2. Amendment/Modification Number	3. Effective Date	4. Requisition/Purchase Request No.	5. Solicitation Caption
DCAM-2011-B-0086-003	25-May-11		**Renovation of 611 N Street Women's Shelter**

RFI RESPONSES AND ADDITIONS FOR 611 N STREET NW

611 N Street NW Women's Transitional and Permanent Supportive Housing

PLAN: TERRACE

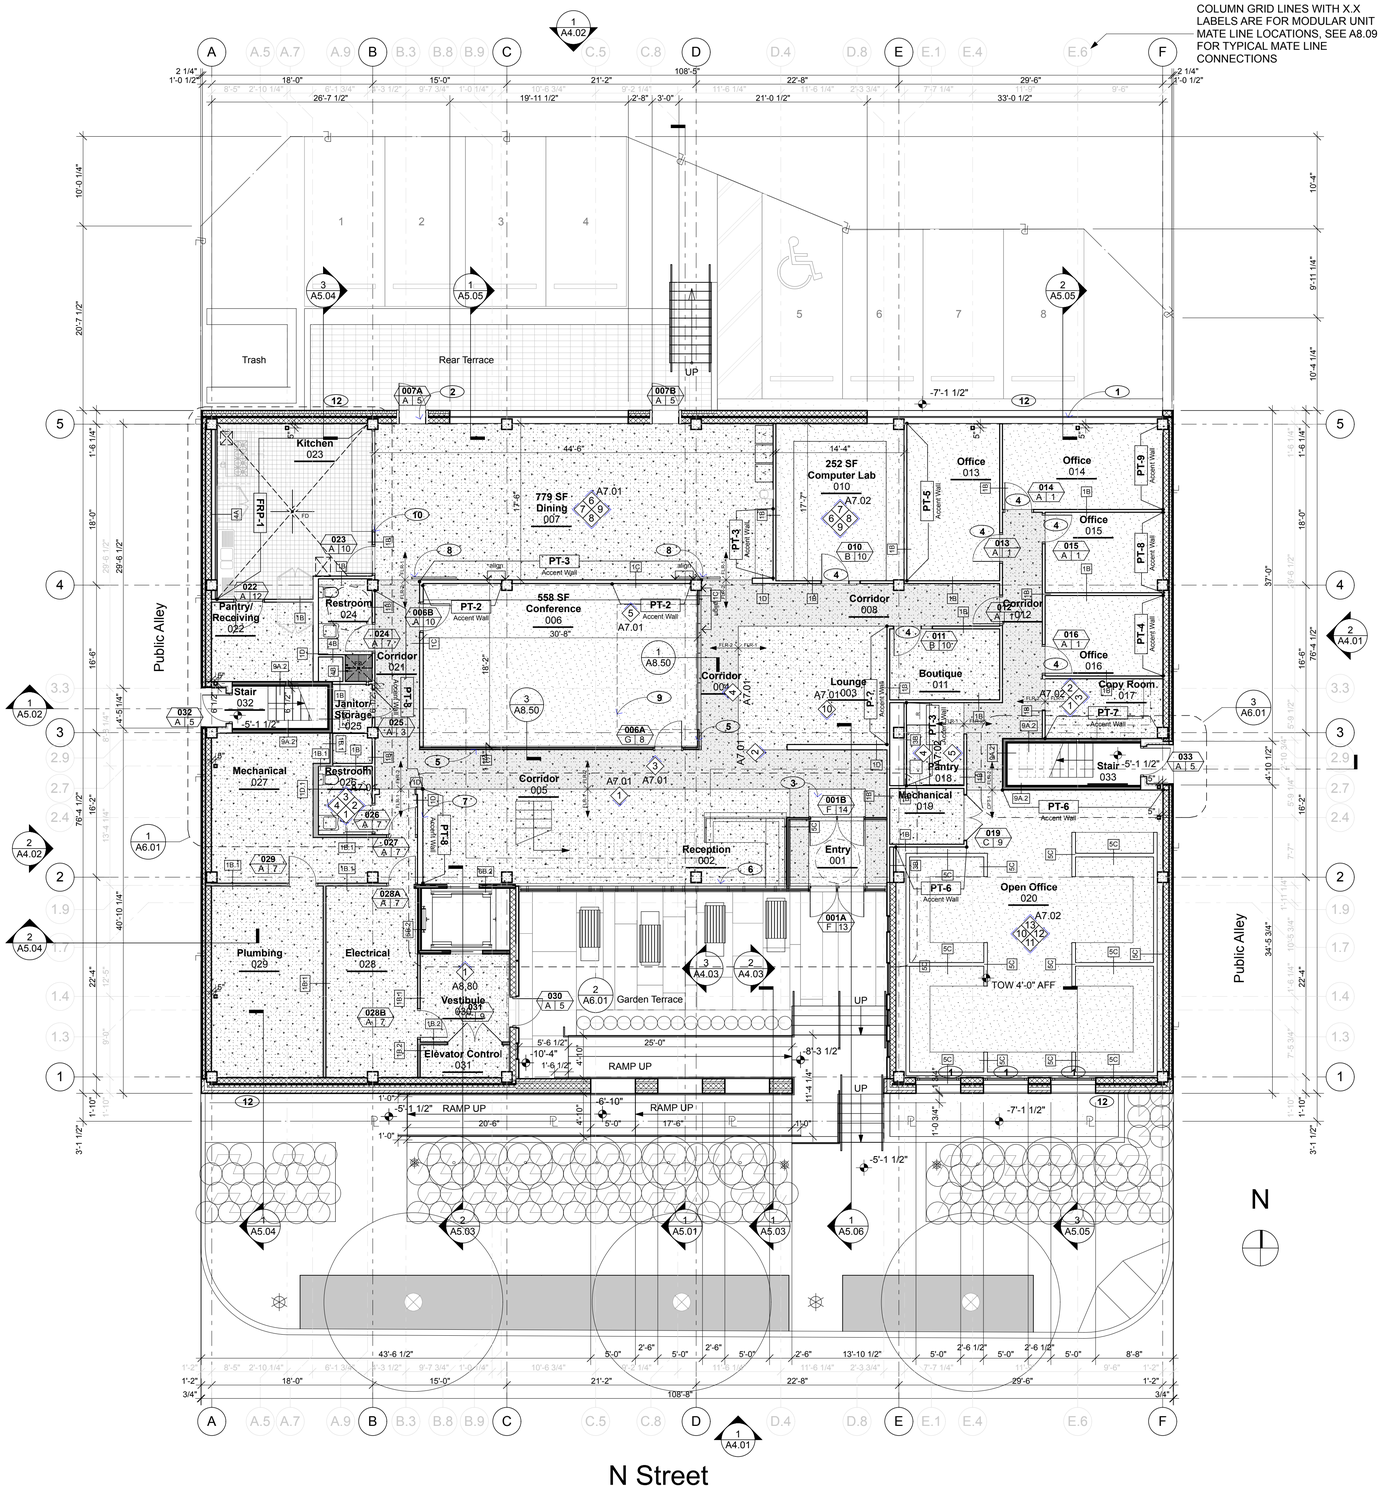
35. Specification sections 071413 and 071616 call for waterproofing work, but no drawing details are given for this particular work. Please provide the missing drawing details.

10. *Rolling countertop door. See 2/A8.50 for detail.*
11. *ADA roll-in shower and grab rails. See A7.04*
12. *Below grade waterproofing to be provided on exterior at all below grade locations. Foundation drains to be provided on North and South walls. See details 5 and 6/A8.30 and 4/8.31 for typical waterproofing details.*

Answer *(CORE): See attached revised sheets A1.01, A5.04, A5.05 and A8.30.*
